# **Errata for the PCI Express<sup>®</sup> Base Specification Revision 5.0**

December 3, 2020

[Figure X: Deadlock Examples with Intersystem Interconnects](#)

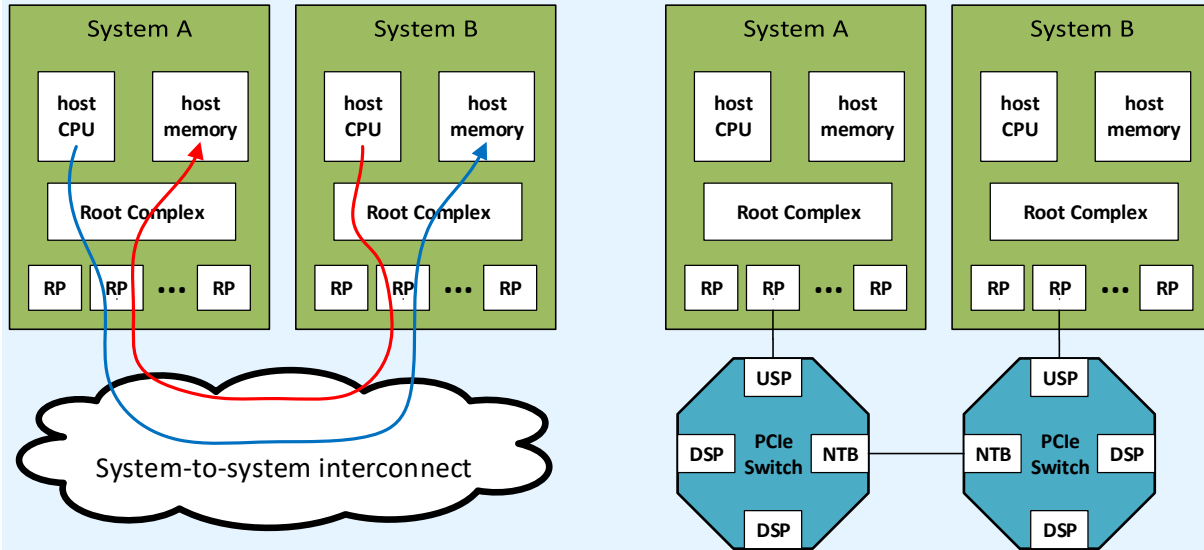
One general case where this may contribute to deadlocks is when two or more systems have an interconnect that enables each host to map host memory in other hosts for Programmed I/O (PIO) access, as shown on the left side of Figure x. A specific example is when two systems each have a PCIe Switch with one or more integrated by Non-Transparent Bridges (NTBs), and the two systems are connected as shown on the right side of the figure.

Deadlock can occur if each host CPU is doing a heavy stream of Posted Requests to host memory in the opposite host. If Posted Request traffic in each direction gets congested, and the Root Port (RP) in each host stops accepting Posted Requests because the RP can't transmit outbound TLPs, deadlock occurs. The root cause of deadlock in this case is actually the adapter to the system-to-system interconnect setting up an acceptance dependency, which is forbidden for Endpoints. For the example case of PCIe Switches with integrated NTBs, the NTBs are Endpoints, and the Switch Upstream Port has the acceptance dependency. While the Root Port's acceptance dependency is not the root cause of the deadlock, it contributes to the deadlock.

[Solutions using this paradigm for intersystem communications will either need to determine that their systems don't have these acceptance dependencies or rely on other mechanisms to avoid these potential deadlocks. Such mechanisms are outside the scope of this specification.](#)

Figure 2-37 PTM ResponseD Message ~~(4-DW header and 1-DW payload)~~

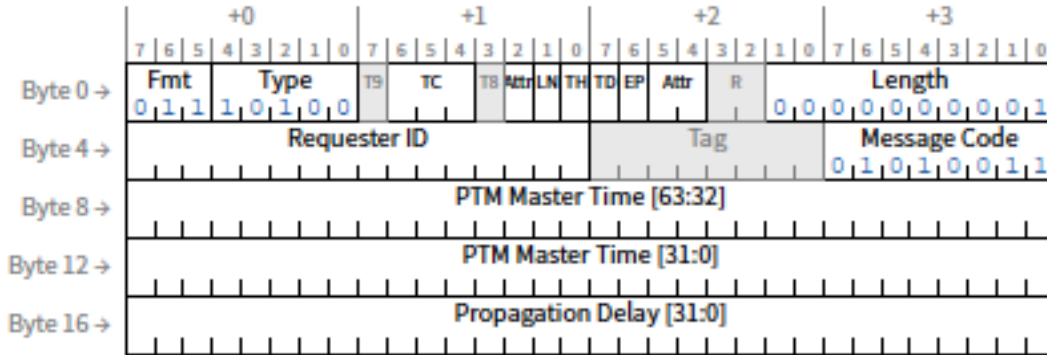
In Section 2.2.8.10, Page 153, Figure 2-37, change the caption as shown and add a new Implementation Note:

The bytes within the Propagation Delay[31:0] field (shown in Figure 2-37) are such that:

- Data Byte 0 contains Propagation Delay [31:24]
- Data Byte 1 contains Propagation Delay [23:16]
- Data Byte 2 contains Propagation Delay [15:08]
- Data Byte 3 contains Propagation Delay [07:00]

Due to ambiguity in previous versions of this document, some implementations made this interpretation:

- Data Byte 0 contains Propagation Delay [07:00]
- Data Byte 1 contains Propagation Delay [15:08]
- Data Byte 2 contains Propagation Delay [23:16]
- Data Byte 3 contains Propagation Delay [31:24]

As a result, it is recommended that implementations provide mechanisms for adapting to either byte interpretation.

*Figure 10-x1 Example Translation Completion with 1 TLP*

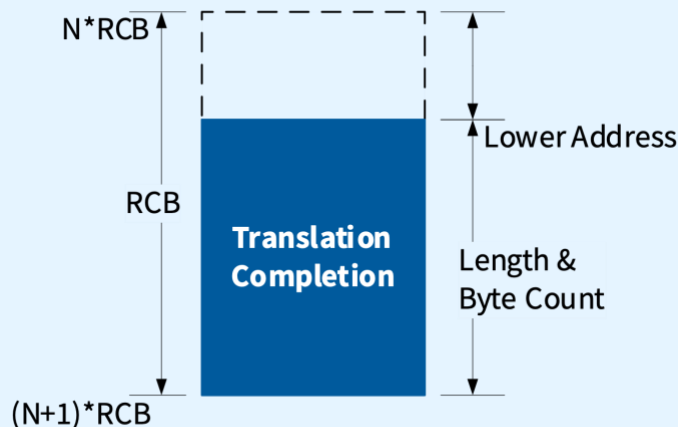
For single TLP Translation Completions, the goal is to make the Completion look as though it is a Memory Read Completion that ends on an RCB. As such, the Length and Byte Count will indicate the same value, and the Lower Address will contain the value that makes the TLP appear to end on an RCB.

To intermediate components (which do not track the transaction) this TLP will be indistinguishable from a Memory Read Completion ending on an RCB.

Figure 10-x2 Example Translation Completion with 2 TLPs

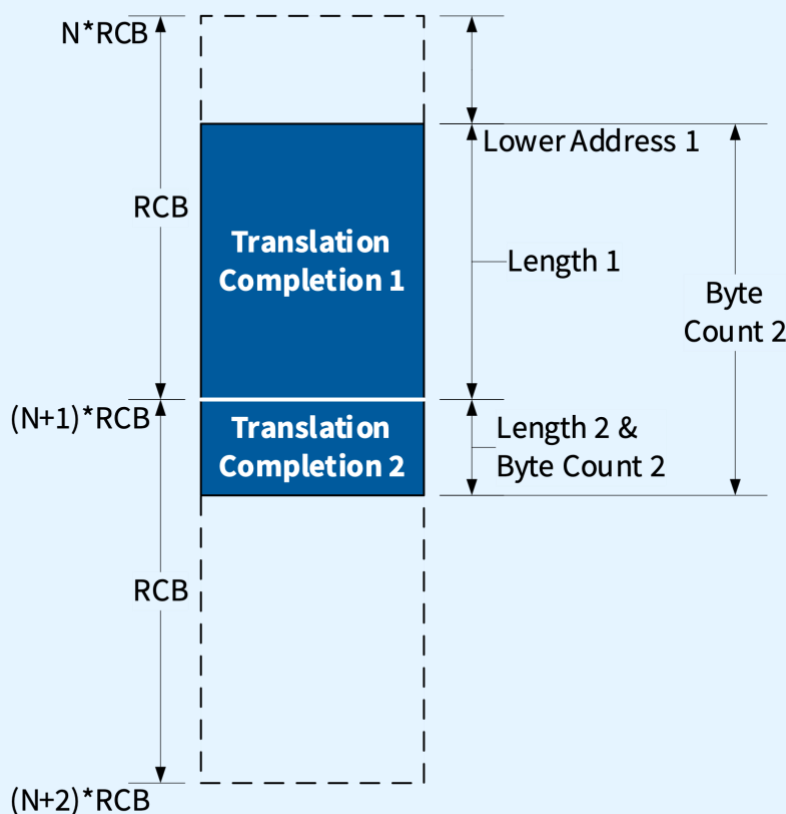
For Translation Completions consisting of two TLPs, the goal is to make the Completion look as though it is a Memory Read Completion that crosses an RCB. As Such, the first Completion TLP will contain Lower Address & Length values which make the TLP appear to end on an RCB. The Byte Count of the first TLP will indicate the total length of all the Translation Completions sent in this transaction. For the second TLP, the Length and Byte Count fields will indicate the same value, and the Lower Address value will be 0.

To intermediate components (which do not track the transaction) this Completion transaction will be indistinguishable from a Memory Read Completion that crosses an RCB.

Figure 10-8 64-bit Translation Request Header

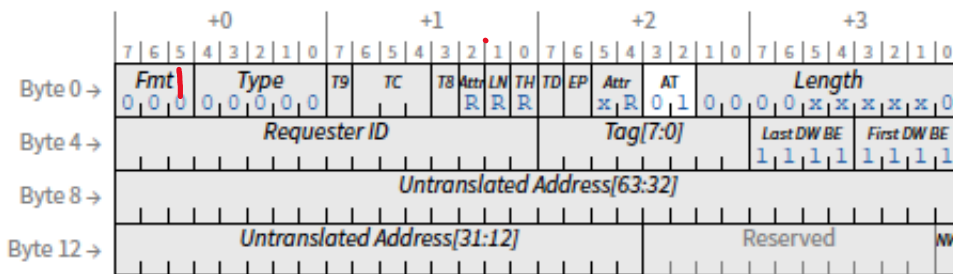
In Figure 10-8, Section 10.2.2, change the Fmt field to 001b

Figure 10-9 32-bit Translation Request Header

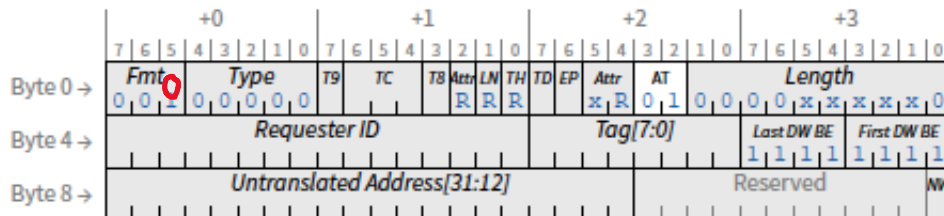
In Figure 10-9, Section 10.2.2, change the Fmt field to 000b

Figure 10-10 Translation Completion with No Data

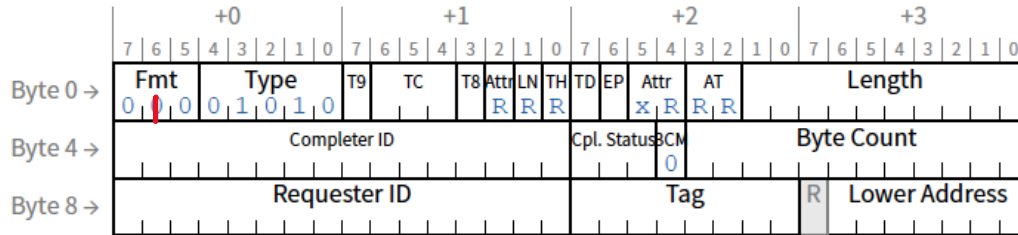
In Figure 10-10, Section 10.2.3, change the Fmt field value to 010b
